SUBJECT : Hyundai ImageQuest Co., Ltd.
FCC ID: PJIL19C0D060
Class II permissive change
Orig. Grant Date: May 28, 2003

Transmitted herewith, on behalf of Hyundai ImageQuest Co., Ltd. is an application for a Class II Permissive Change Certification of the following 19-inch LCD Monitor:

FCC ID : PJIL19C0D060
Model/Type : L90D/ L19C0D060

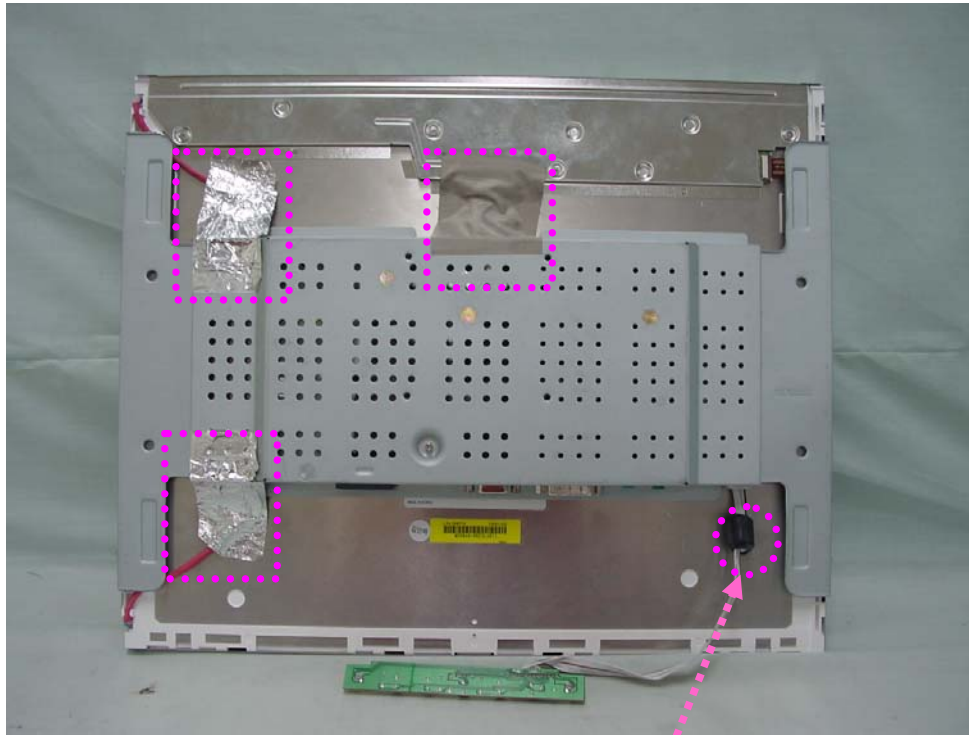
1. Attach a aluminum foil between Main Frame and LCD panel

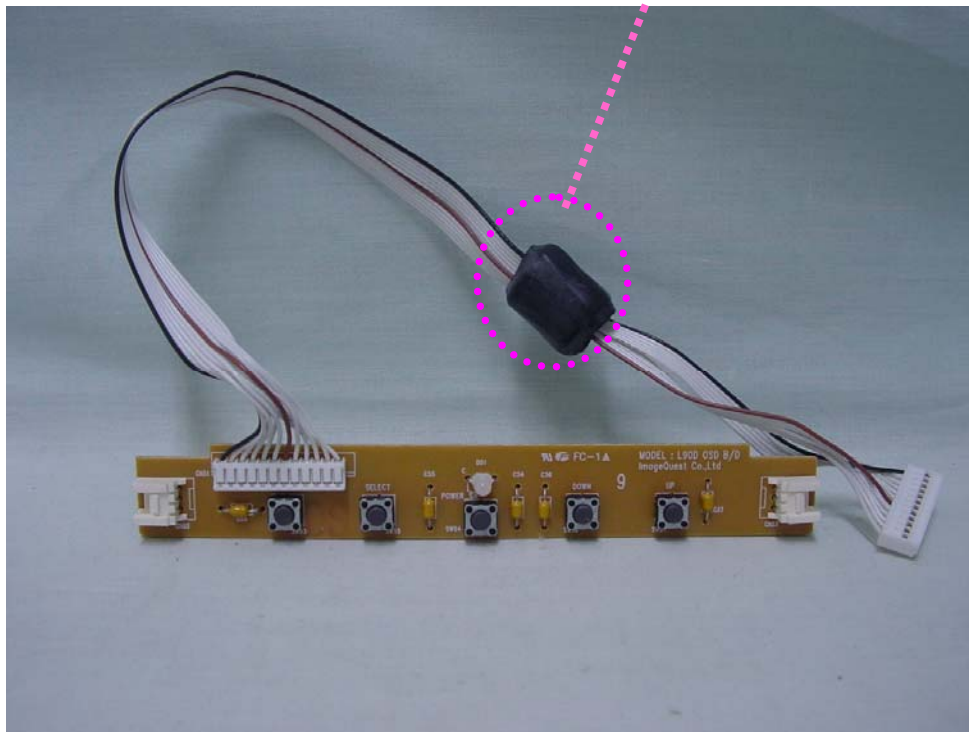
2. Apply a ferrite Core to the OSD board signal cable

3. Attach a gasket on the Main Board and Main Frame to contact a LCD panel
